Subject: Geometry

today I committed an update on the beampipe geometry, and I wanted to take a look into what is happening inside the region of the vertex detector (MVD_Rev14b_Corr+Dead.geo):

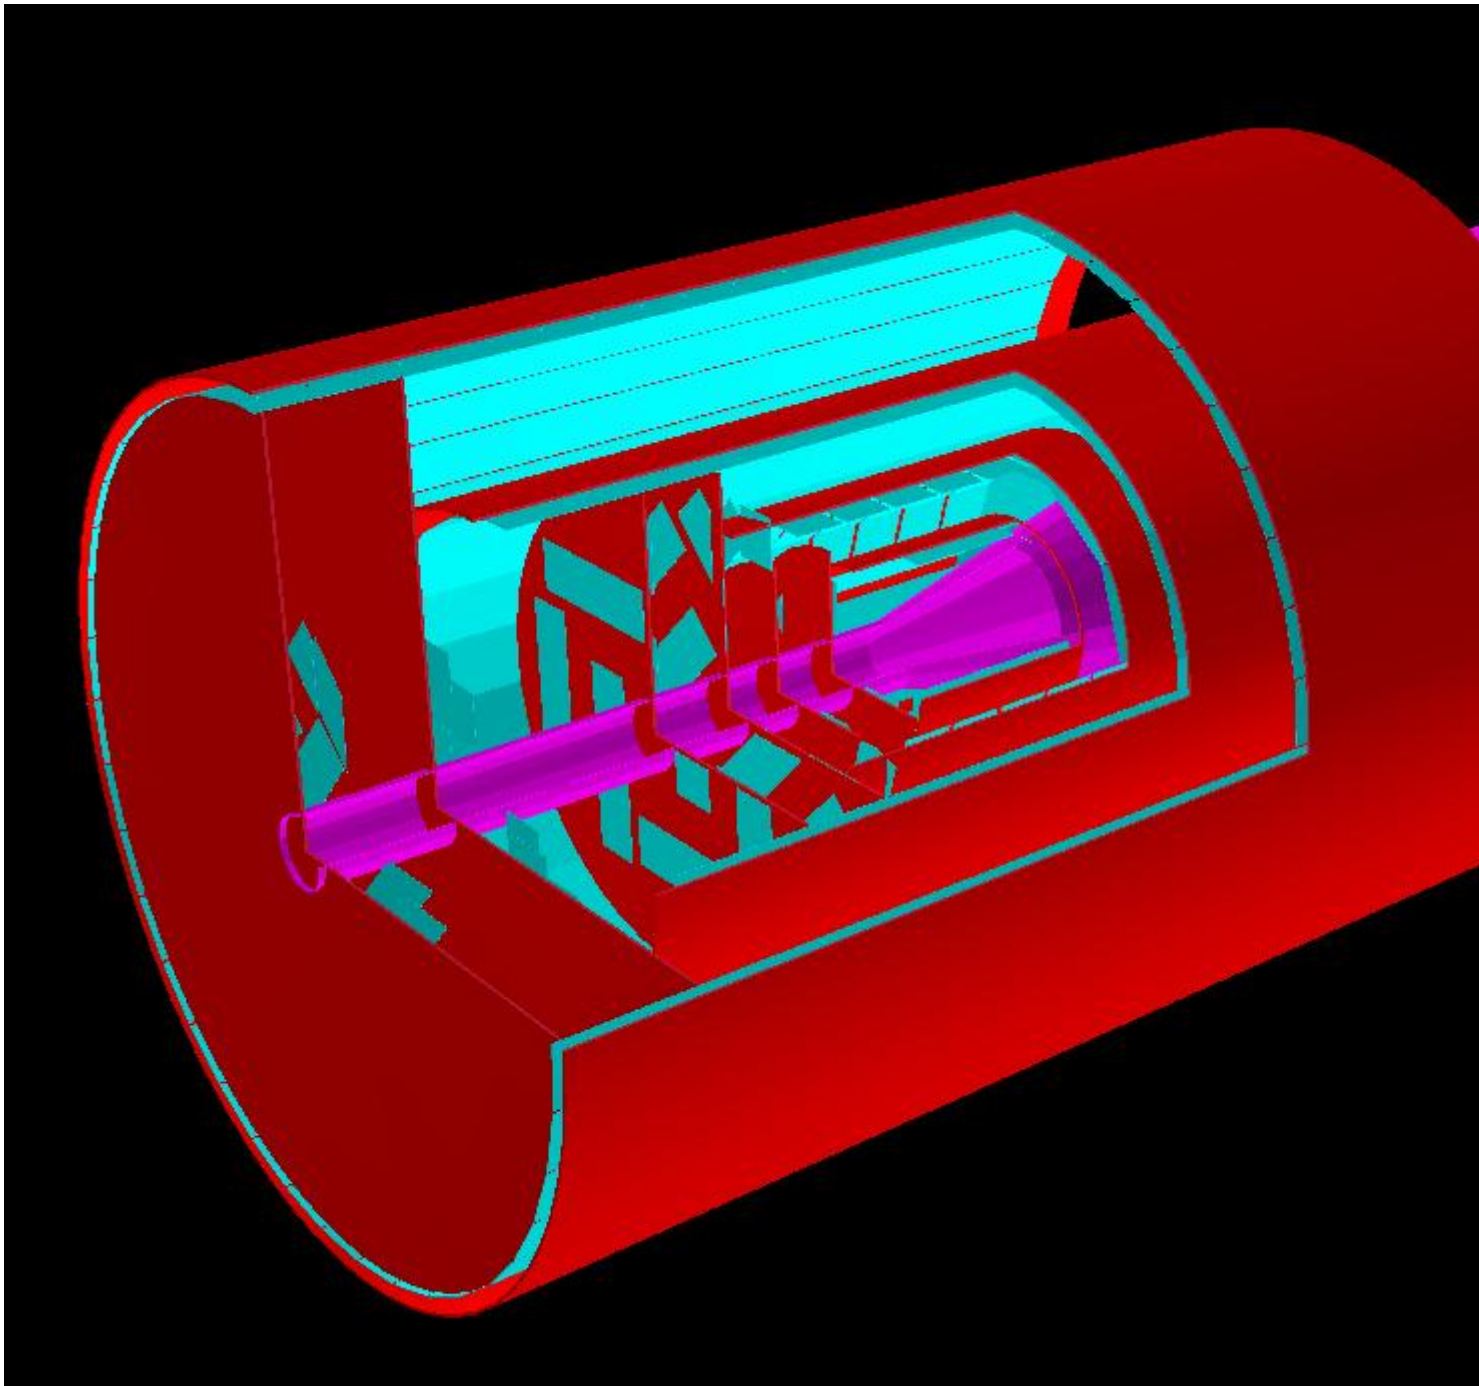
It seems that the forward disks (I think the dead layers) are completely full, and there is no space for the beampipe -> there is overlap between volumes.

I don't know exactly how the geometry will look like, but is it possible to open one hole so that at least we do not have overlap there?

Hi Stefano,
Tobias has an updated geometry from the CAD files, with a detailed support structure and cooling. However the implementation is not ready yet.
